AGENDA
NOTICE AND CALL OF SPECIAL MEETING OF THE
CITY COUNCIL OF THE CITY OF MORENO VALLEY

TITLE: A PUBLIC HEARING REGARDING AN APPEAL OF THE PLANNING COMMISSION DENIAL OF A ZONE CHANGE (PA08-0098) FROM BUSINESS PARK (BP) TO LIGHT INDUSTRIAL (LI) FOR A 55 ACRE SITE FOR THE WEST RIDGE COMMERCE CENTER PROJECT. THE PROJECT ALSO INCLUDES A PLOT PLAN (PA08-0097) FOR A 937,260 SQUARE FOOT WAREHOUSE FACILITY; TENTATIVE PARCEL MAP NO. 36207 (PA09-0022) TO CREATE A SINGLE PARCEL; AND A MUNICIPAL CODE AMENDMENT TO PROVIDE A MINIMUM SEPARATION/BUFFERING OF WAREHOUSE/INDUSTRIAL FACILITIES OVER 50,000 SQUARE FEET FROM ADJACENT RESIDENTIAL DISTRICTS. AN ENVIRONMENTAL IMPACT REPORT HAS BEEN PREPARED FOR THE PROJECT. THE PROJECT SITE IS LOCATED ON THE SOUTH SIDE OF STATE ROUTE 60, ON THE NORTH SIDE OF EUCALYPTUS AVENUE AND APPROXIMATELY 650 FEET WEST OF REDLANDS BOULEVARD. THE APPLICANT IS RIDGE RANCHO BELAGO, LLC.

ALQUIST-PRIOLO EARTHQUAKE FAULT ZONE MAP
PROPOSED WEST RIDGE BUSINESS CENTER
MORENO VALLEY, CALIFORNIA

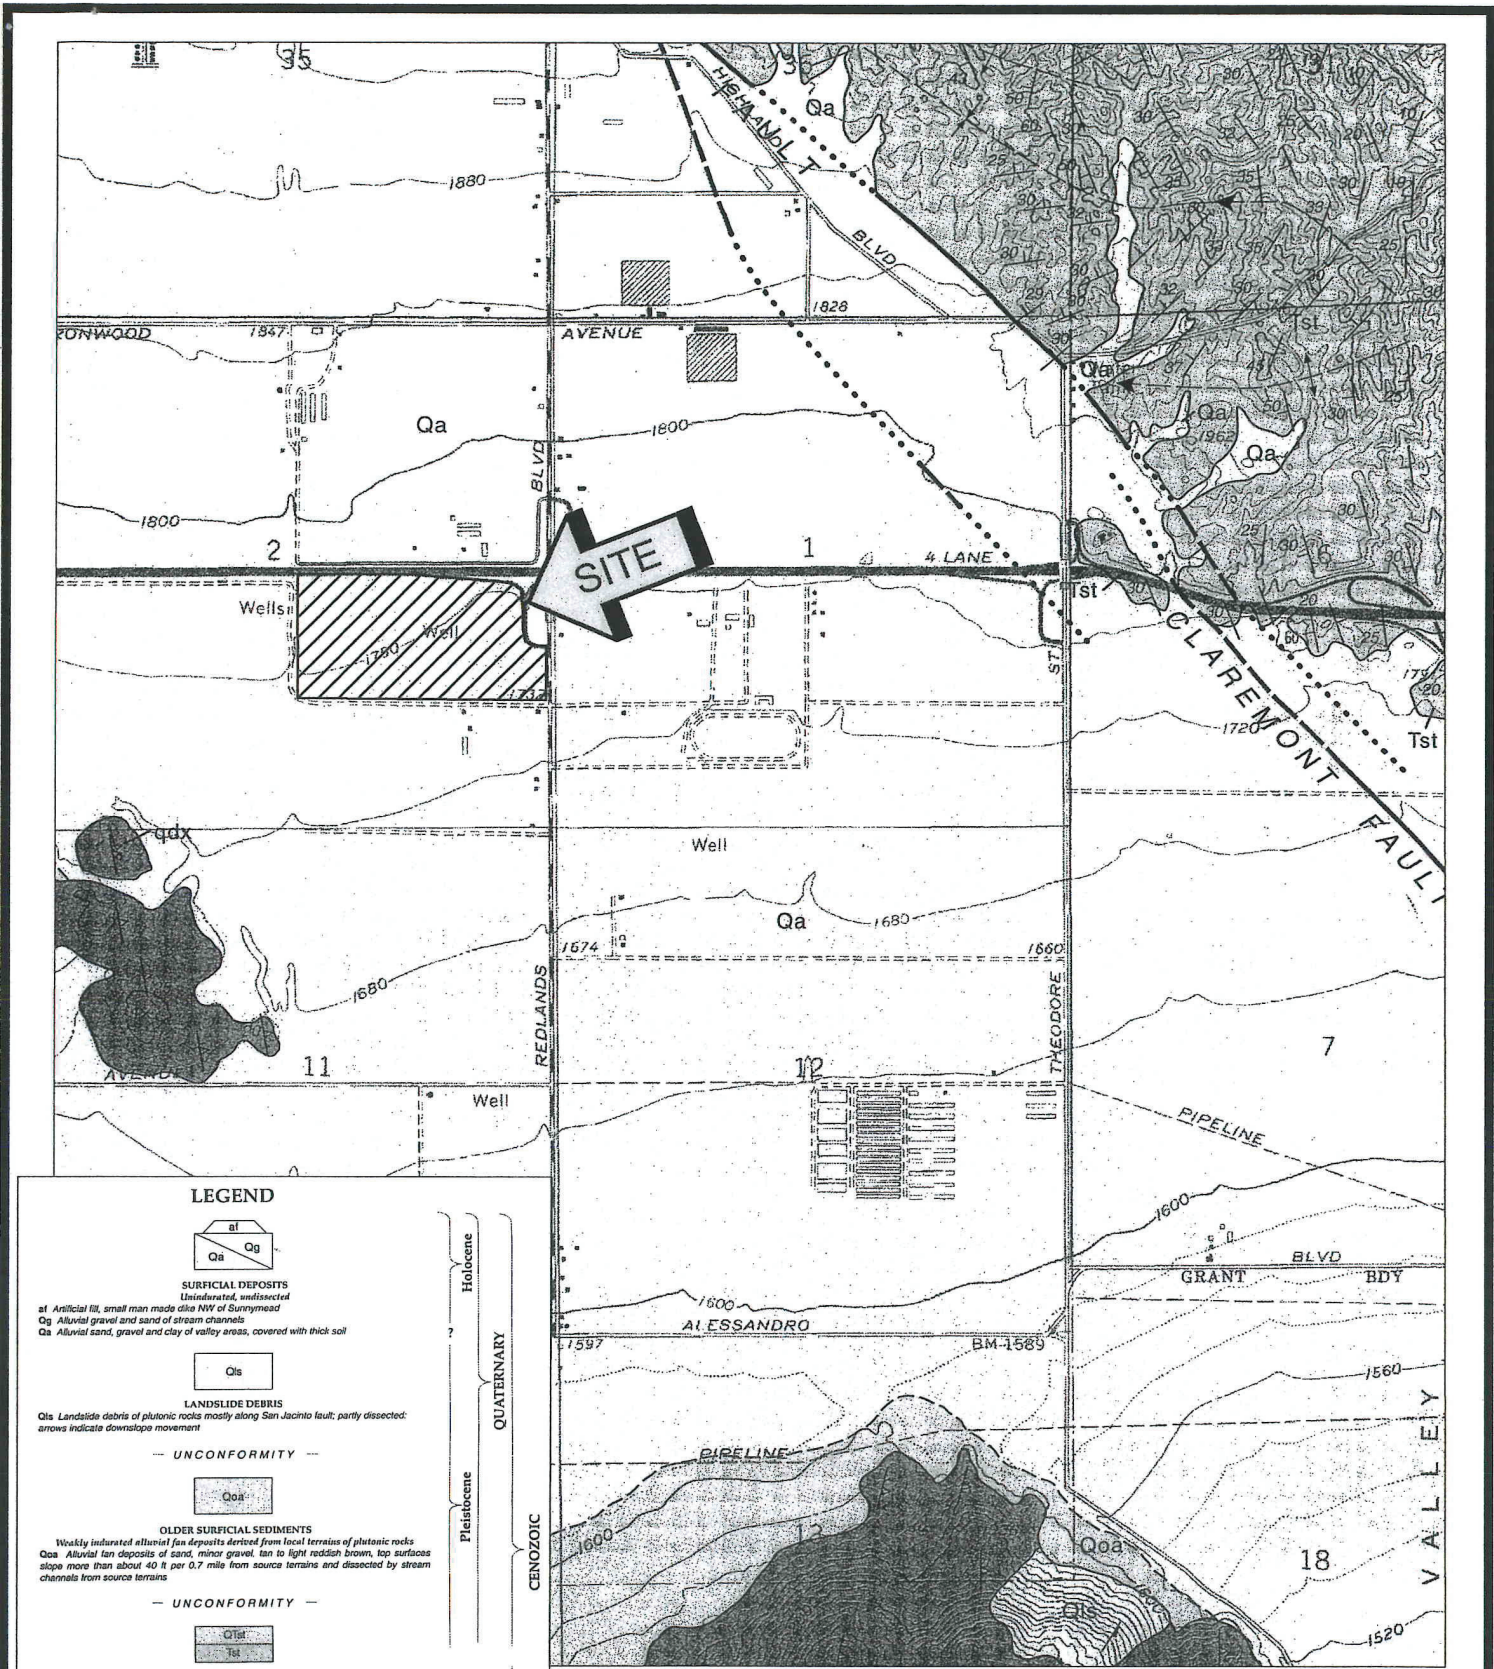
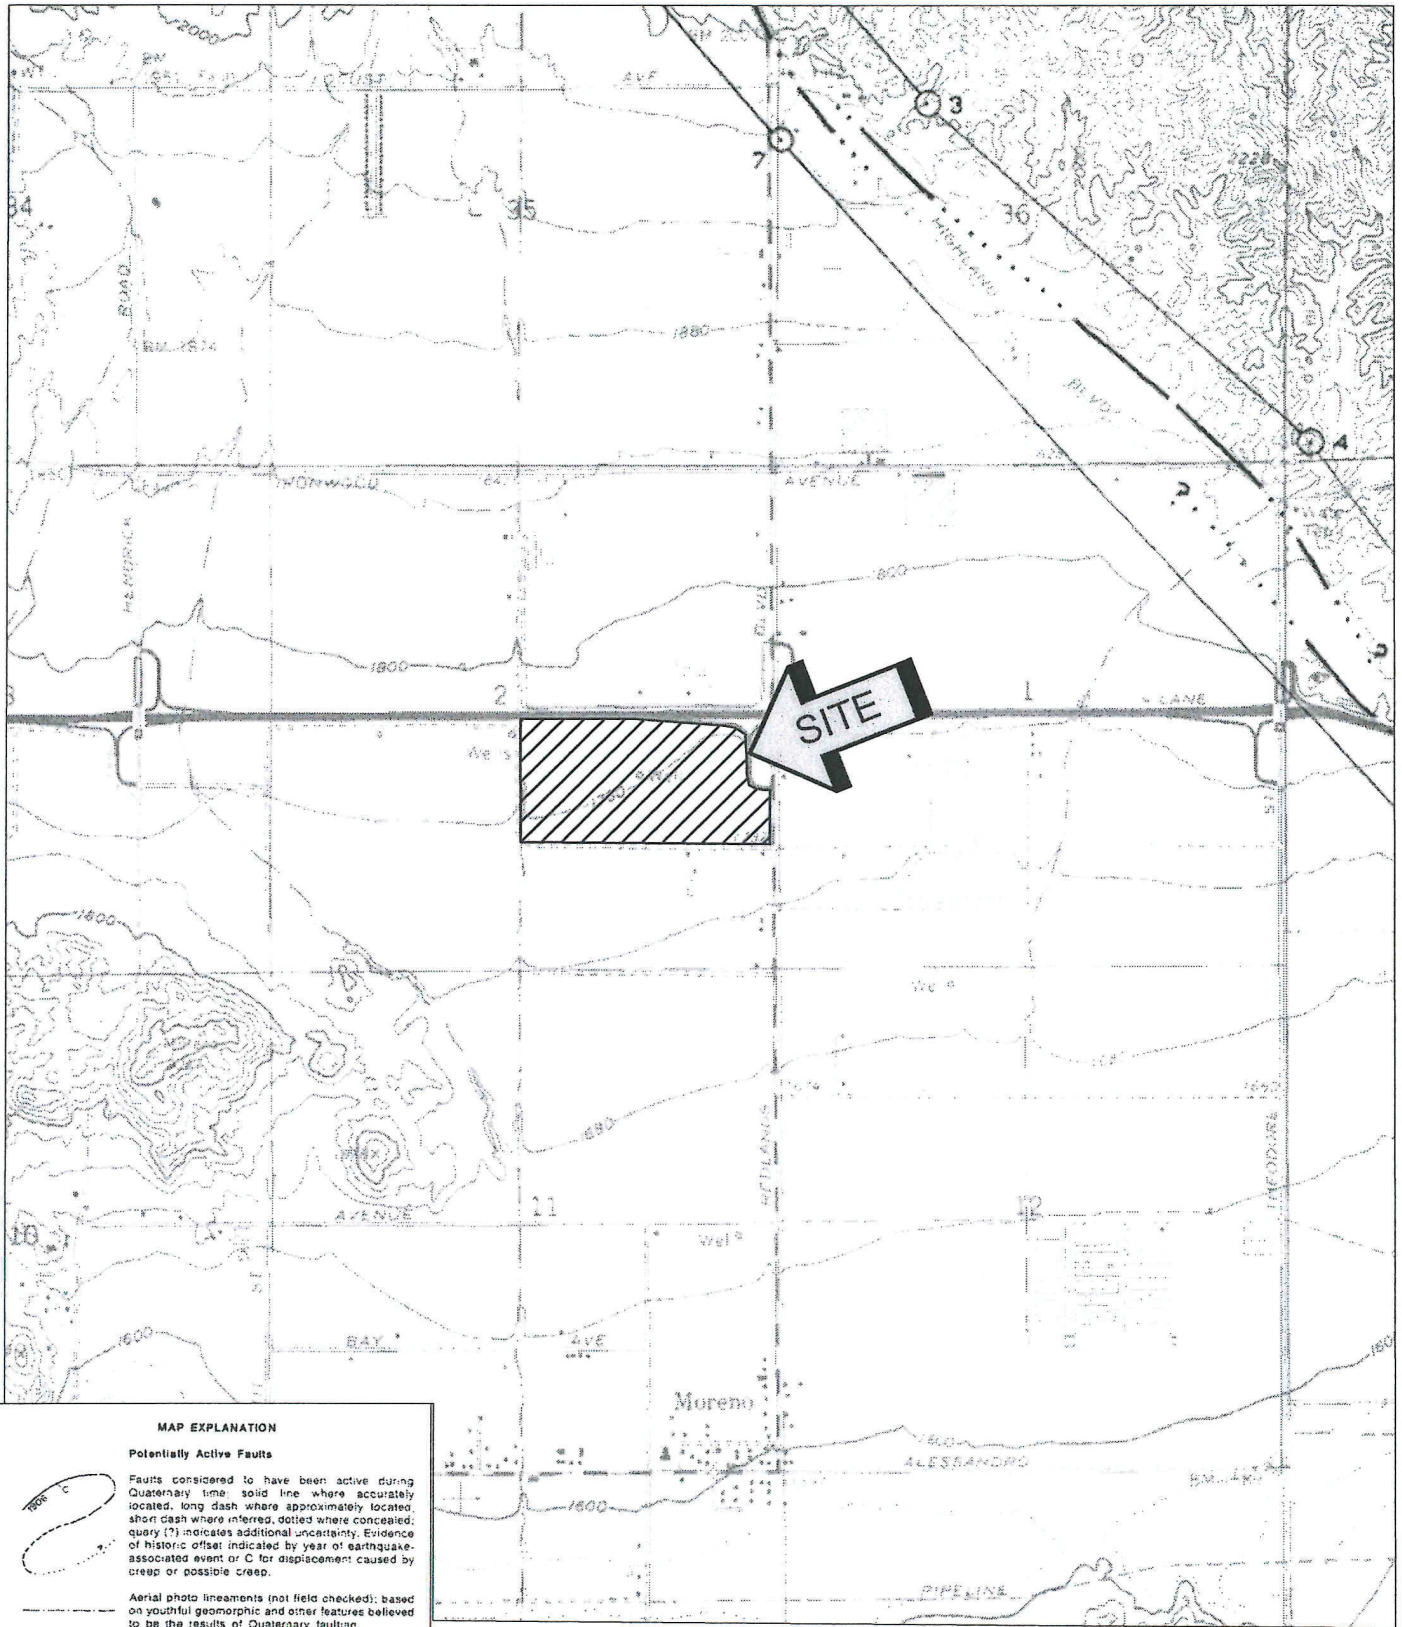
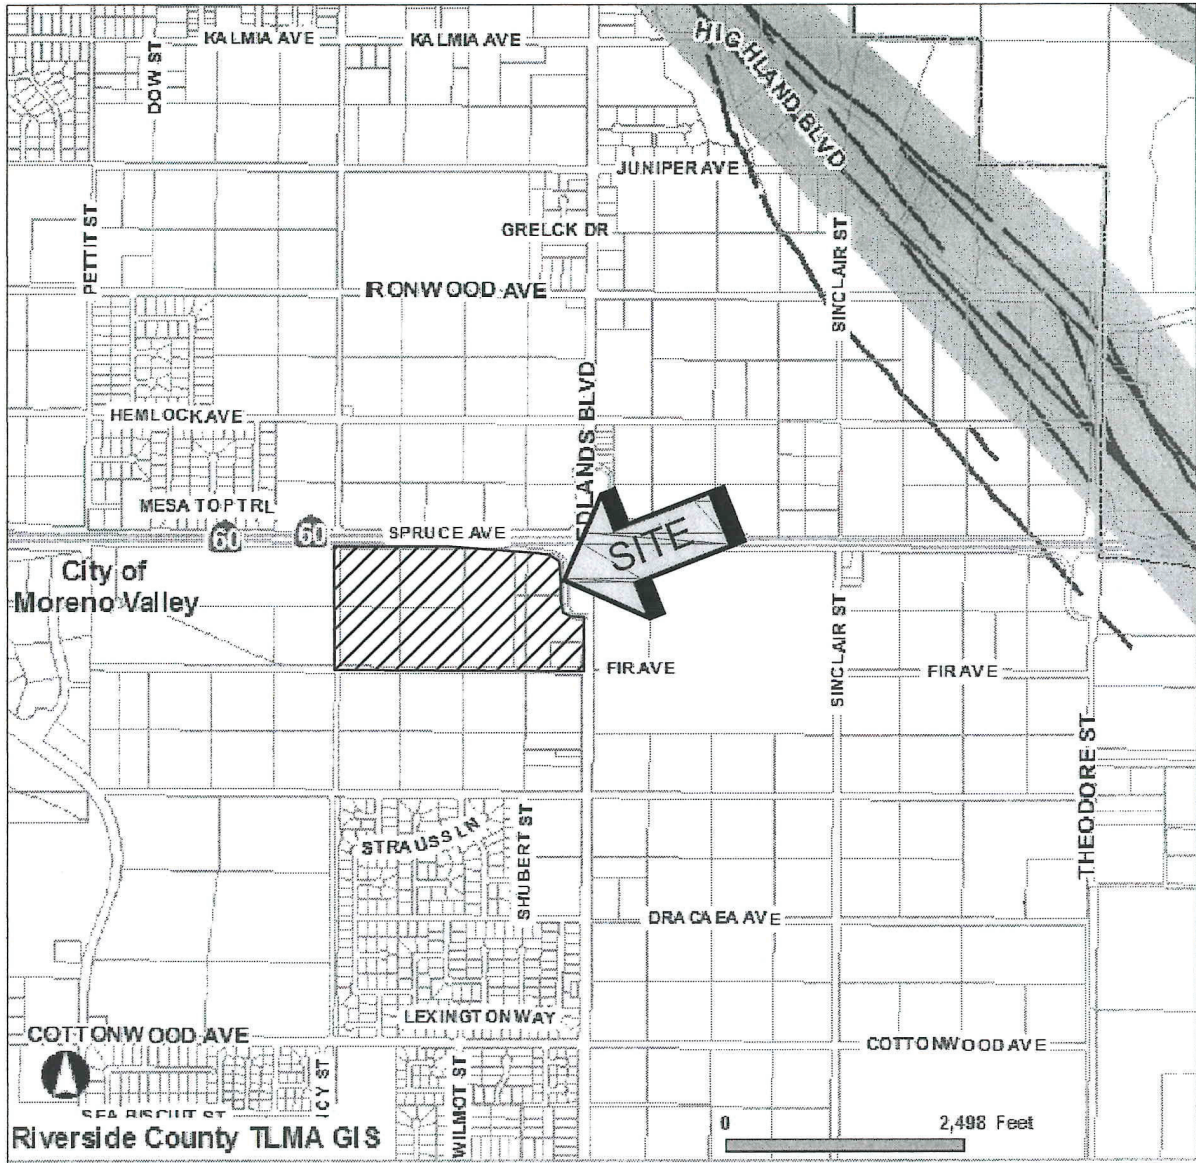
In response to comments received from Gerald M. Budlong, a City of Moreno Valley Environmental and Historical Preservation Board member, several geologic maps, which were used as points of reference in the preparation of the Project Geotechnical Investigation, are incorporated on the following pages as “Plates 1 through 4.”

2.3 REVISIONS TO GRAPHIC ILLUSTRATIONS
